Access Compliance Report

Public Rights-of-Way

(Curb Ramps)

Intersection ID: 7342	Main Street: TOM_HUNTER_RD	Cross Street: PROSPECT_DR	Location: NE
ADA ID: FBE0879DAAF8	Ramp Type: Para	Initial Pass/Fail: Fail	Overall Compliance: No
Codes/Mitigation Info/Possible Solution		Field Measurements/Component Compliance

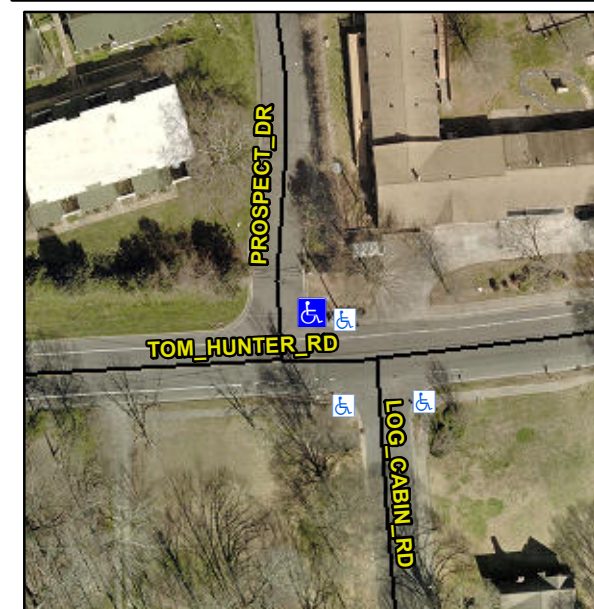
Surveyor Notes:

LT RP SL < 5%, NO LT SW

PROW/ADA:

R304.5.3, R304.3.2

Possible Solutions:

Remove & Replace Entire Ramp.
